Valentine Gold Project: Notification of Change to a Designated Project

Final Report

Calibre Mining Corporation
Valentine Gold Mine
7 Queensway
Grand Falls-Windsor, NL
A2B 1K9

May 7, 2025

Figure No. **2.1**
Title
Project Refinements Layout

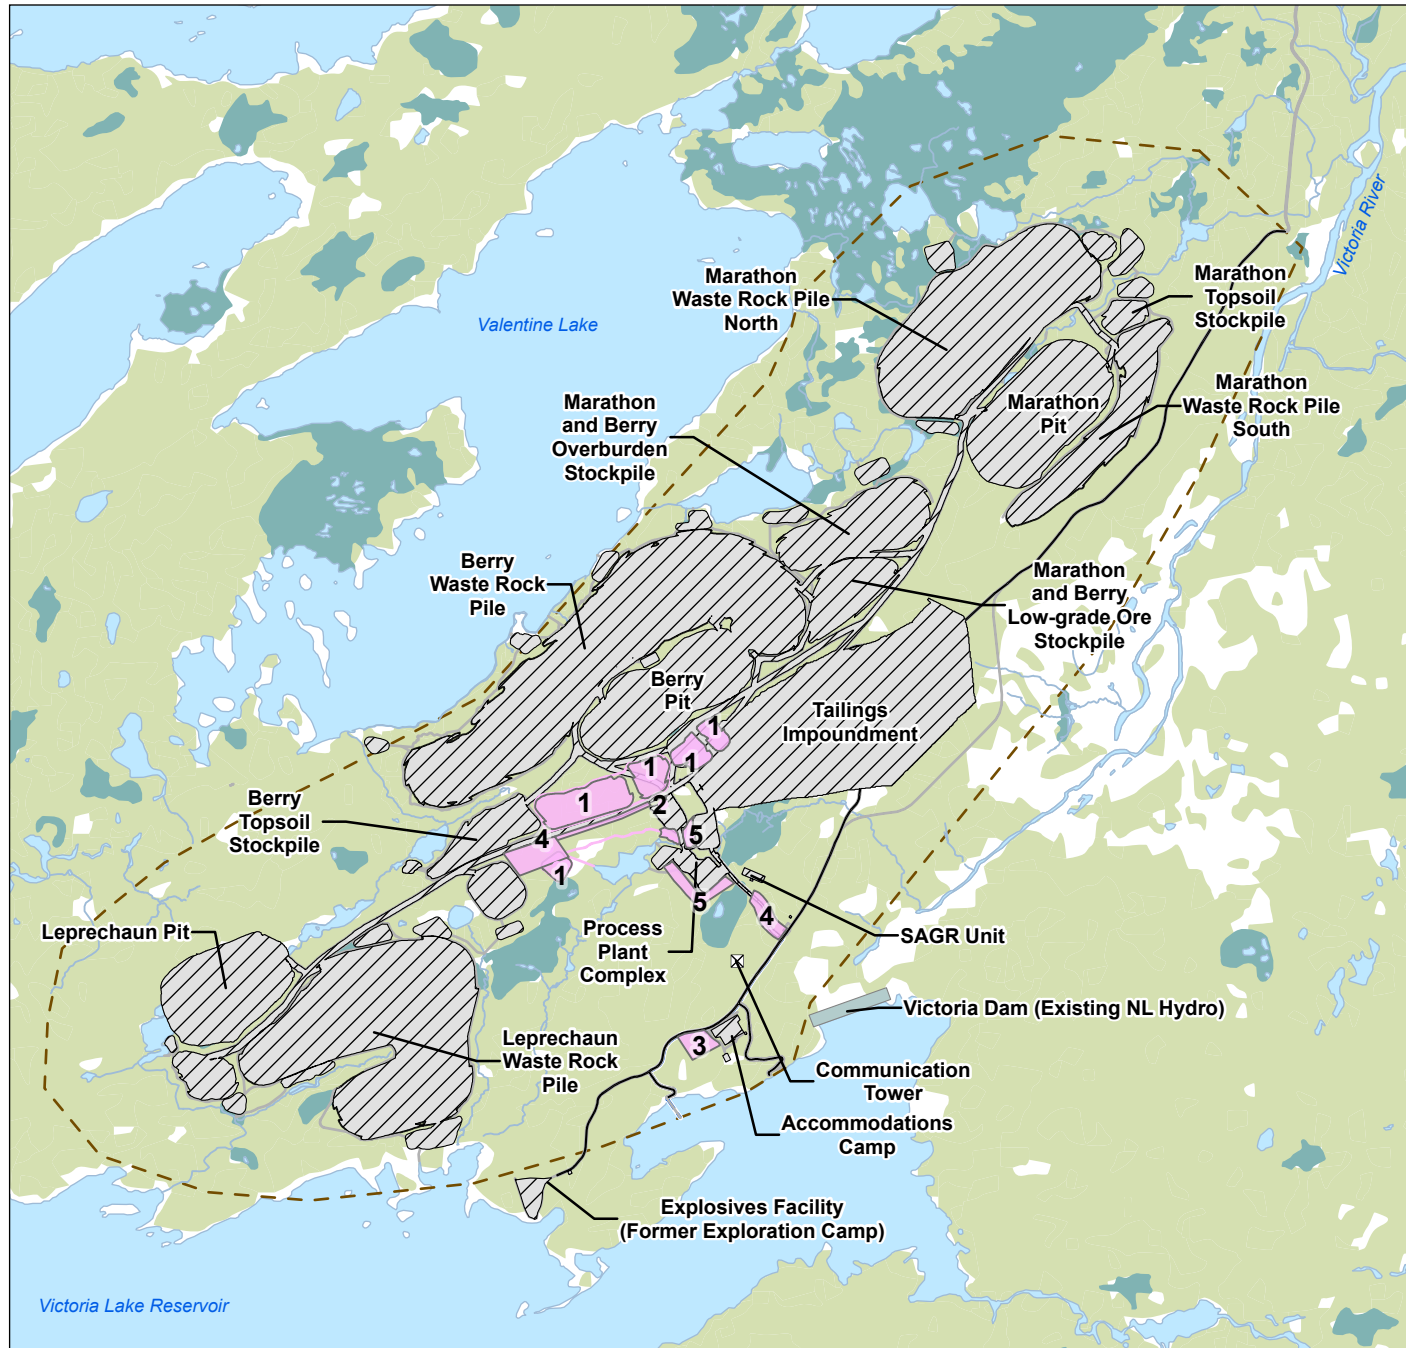
Corresponding # on Figure 2.1	Project Refinement	Rationale for Refinement
1.	<p>Calibre proposes the separation of the HGO stockpile into two high-medium grade (HMG) ore stockpiles and two medium-grade (MG) ore stockpiles. Two of these stockpiles are within the footprint of the originally planned HGO stockpile and two additional stockpiles proposed are outside the tailings management facility (TMF) drainage footprint. Additional detail on the stockpile refinements is provided in Section 2.1. This will result in an increase in the stockpile footprints by 22.09 ha. The stockpiles will be developed in a manner consistent with development of other stockpiles for the Project and as outlined in Section 2.3.2.3 of the EIS. Water management infrastructure, including ditches and a sedimentation pond will be required to support this modification. This will result in an increase in the water management footprints by 2.99 ha. Additional detail on the water management refinements is provided in Section 2.2.</p>	<p>The changes to the HGO stockpiles are required due to a combination of factors, including increasing gold price and related decreases in cut-off grade, refinements to the mine plan, improved flexibility to blend and/or separate HGO materials for processing, and the need to maintain space for HGO material after the original HGO stockpile location is needed for tailings storage.</p>

2.	<p>Calibre proposes to increase the approved diesel fuel storage of 450,000 litres (Section 2.3.13 of the EIS) to 950,000 litres. The fuel storage area will be upgraded with full liner system, concrete bases, double contained tanks, and oil water separators to accommodate the additional storage capacity.</p>	<p>The expanded fuel storage capacity will provide Calibre with the ability to store more fuel, thereby increasing operational flexibility in the case fuel trucks are unable to reach the site at certain times of the year due to weather and/or road conditions. The number of annual trucks is not anticipated to increase as a result of the additional storage, but the timing of deliveries would be altered around seasonal restrictions on road access.</p>

3.	<p>The camp expansion is proposed west of the existing camp facility and will result in an increase of 3.74 ha. The expansion is temporary and expected to be required for two to four years. The camp area expansion would include additional parking areas, the addition of up to 250 rooms, as well as a temporary kitchen and upgrades to the existing potable water and sewer treatment plants. The camp expansion will support more workers (contract) and will increase road traffic on the access road (approximately an additional 2-3 busses (return trips) every two weeks, plus equipment mobilization). An additional back-up generator will also be required; currently there are two back-up generators for the current camp setup, a third will be required for this expansion (600KW - 1.1MW (to be determined)).</p>	<p>The camp expansion is required to accommodate additional contracted personnel on site related to changing schedules for continued construction activities, which are now overlapping with operations. Greater overlap of ongoing and future construction personnel with operations personnel will require additional camp-related facilities for the next two, and possibly up to four years.</p>

Corresponding # on Figure 2.1	Project Refinement	Rationale for Refinement
4.	Additional laydown areas, as shown on Figure 2.1, are proposed for storing materials, equipment, and/or supplies, resulting in a footprint increase of 12.59 ha. In addition, there is a section of haul road that will be widened. Site preparation and earthworks will be conducted in a manner consistent with other site preparation activities conducted for the Project, and as outlined in Sections 2.4.1 and 2.4.2 of the EIS. The laydown areas will only be used for mobile equipment, construction materials, and bulk project supplies, such as high-density polyethylene piping, rebar, and lumber.	Additional laydown areas are needed to provide flexibility to accommodate changes and fluctuations in storage requirements and materials arriving on site. The location of the new, proposed laydown areas are planned in areas to increase logistical efficiency for better planning of material deliveries and streamlined movement and maintenance of equipment.

5	An addition is proposed to the south and west extent of the process plant pad, and areas adjacent to the crusher and conveyor. The additional areas are expansion of working areas only and no new infrastructure development / construction (i.e., buildings) is required. This will result in a footprint increase of 6.96 ha. Site preparation and earthworks will be conducted in a manner consistent with other site preparation activities conducted for the Project and as outlined in Sections 2.4.1 and 2.4.2 of the EIS.	The additional space adjacent to the crusher and conveyor is required to provide improved access for maintenance and improved efficiency and safety. The expansion to the south and west of the process plant pad is to provide further space for equipment movement and operation (e.g., cranes for Phase 2 construction and operational maintenance), and temporary laydown.

HMG AND MG STOCKPILE DRAINAGE AREAS
SURFACE WATER MANAGEMENT

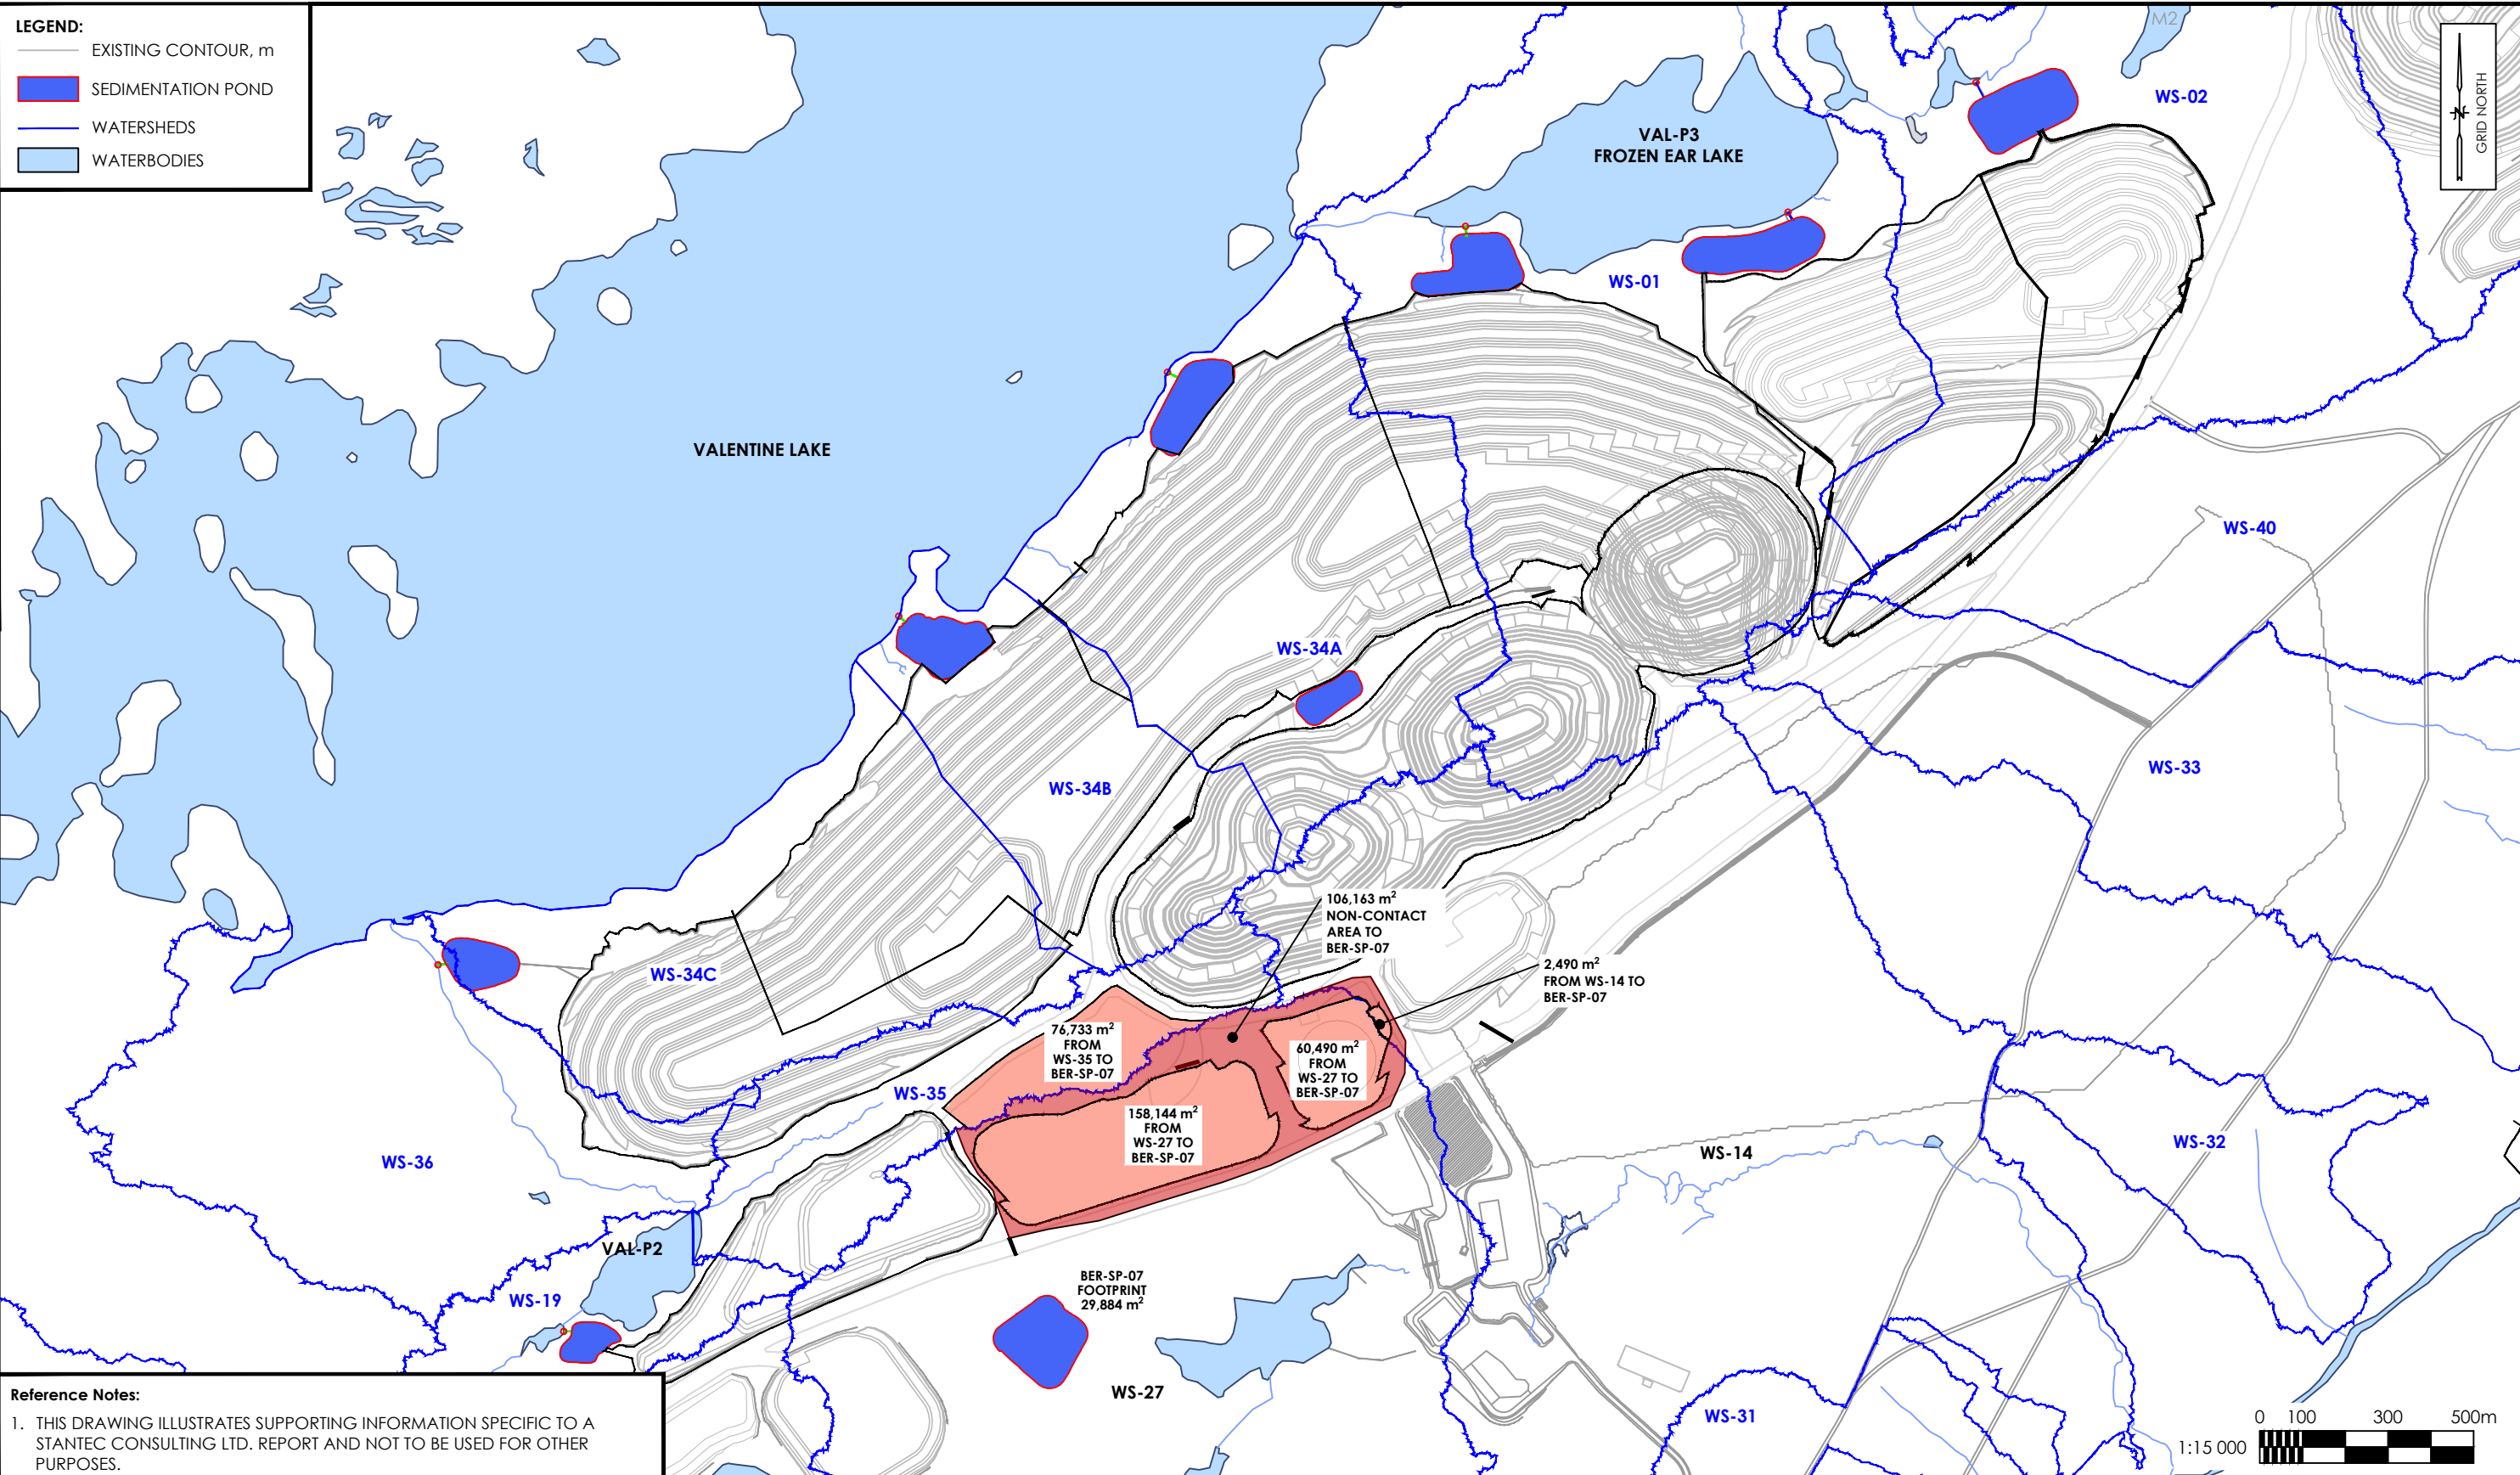
Water management infrastructure, including ditches and a sedimentation pond, will be required to support modifications to the stockpiles (Figure 2.2). The split HMG and MG stockpiles replacing the former HGO stockpile will not require a drainage plan revision as the piles are located within the drainage footprint of the TMF and will continue to be managed as part of TMF water management. The new HMG and MG stockpiles to the west will require perimeter runoff collection ditching and a downstream sedimentation pond (BR-SP-07). The sedimentation pond will be designed to provide adequate residence time for settling and have controlled release discharge via a new final discharge point (FDP), BR-FDP-07, to the nearest natural waterbody, Pond L2, which will meet the *Metal and Diamond Mining Effluent Regulations* (MDMER) limits. Pond L2 drains via unnamed watercourse 27 to Victoria Lake Reservoir. Due to the potential for acid rock drainage (ARD) from the HMG and MG ore, the sedimentation pond will exclusively manage runoff from these piles. ARD potential will be monitored for the MG stockpile where ore may reside in the pile longer than the ARD onset time. If the monitored water quality at the sedimentation pond increases towards MDMER limits, the pond discharge to the environment will be blocked and the water will instead be transferred via pipeline to the mine's Effluent Treatment Plant for treatment prior to discharge to the environment.

The drainage area to BER-SP-07 is 15.8 ha for the MG stockpile, 6.2 ha for the HMG stockpile and 16.2 ha for disturbed ground around the piles and surrounded by haul roads. The pond will have an approximate active storage capacity of 59,000 m³ and 17,000 m³ of dead storage, with a maximum depth of 6 m. The pond has an approximate surface area of 29,880 m².
